Errata to IEEE Guide for the Interpretation of Gases Generated in Mineral Oil-Immersed Transformers

Correction Sheet
5 December 2019

Figure D.1—Duval Pentagon 1 Method

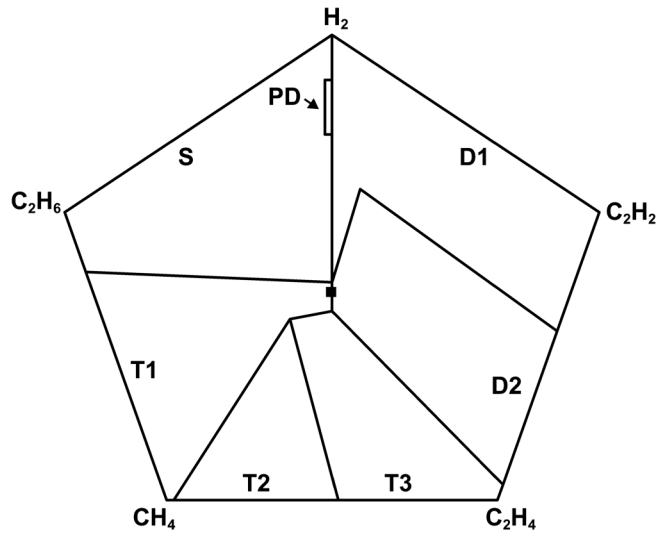
In Figure D.1 on page 62, change the line between T1 and T2 as follows:
